## **Accessibility Survey**

# 10th Street - Brookshire Avenue to Birchdale Avenue

Date of Inspection 7/14/2017

**Disability Access Consultants**

## Change in Level East of Brookshire Avenue @ 33.947628758485, -118.120503276587

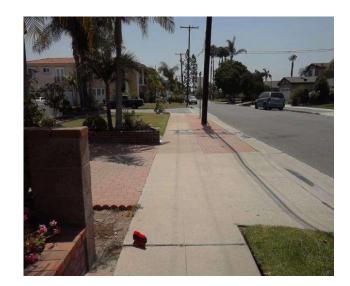
There is a change in elevation greater than recommended value.

On-Site Finding 0.62 inches

Ensure that the change in elevation is within the recommended value.

Recommendation Up to 0.25 inches

## Change in Level East of Brookshire Avenue @ 33.948187237195, -118.121607005596

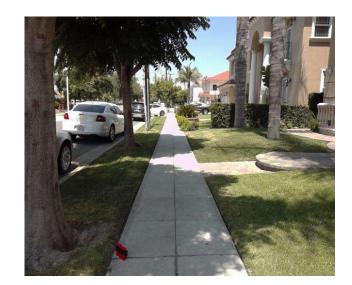
There is a change in elevation greater than recommended value.

**On-Site Finding** 0.50 inches

Ensure that the change in elevation is within the recommended value.

Recommendation Up to 0.25 inches

## Change in Level East of Brookshire Avenue @ 33.948354112592, -118.121940940619

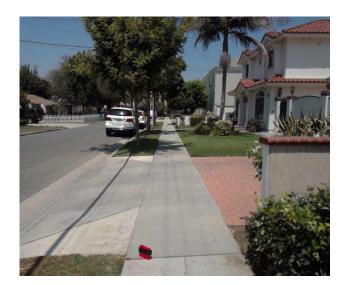
There is a change in elevation greater than recommended value.

**On-Site Finding** 0.50 inches

Ensure that the change in elevation is within the recommended value.

Recommendation Up to 0.25 inches

## Change in Level West of Birchdale Avenue @ 33.948286249970, -118.122111260891

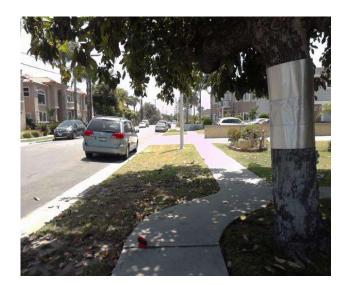
There is a change in elevation greater than recommended value.

**On-Site Finding** 0.50 inches

Ensure that the change in elevation is within the recommended value.

Recommendation Up to 0.25 inches

## Northeast Corner of Brookshire Avenue @ 33.948690087400, -118.122611492872

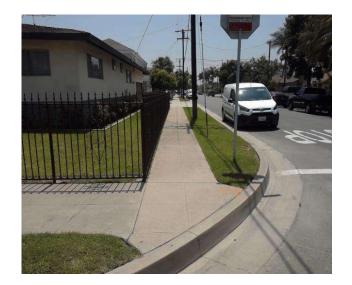
There is a curb on the designated path of travel.

**On-Site Finding** Not Compliant

Provide a compliant curb ramp.

## Tree East of Brookshire Avenue @ 33.948490950174, -118.122211843729

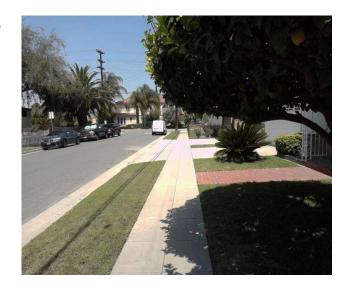
Overhead obstruction height is not compliant.

On-Site Finding 68.00 inches

Provide a compliant vertical clearance height.

Recommendation At least 80.00 inches

## North Side @ 33.948691199897, -118.122610151768

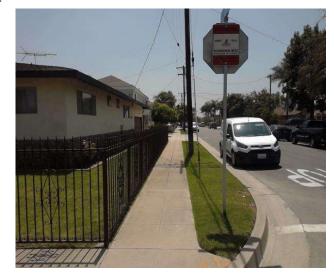
There is no 60X60 turn area at every 200 feet.

**On-Site Finding** Not Found

Provide a 60X60 turn every 200 feet on the sidewalk.

## Sidewalk West of Birchdale Avenue @ 33.948085999294, -118.121715635061

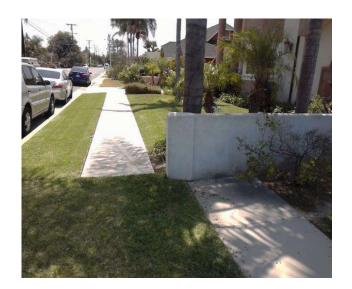
Section of sidewalk is missing and consists of dirt, grass or gravel.

**On-Site Finding** 5.00 feet

Provide a compliant sidewalk for the missing section.
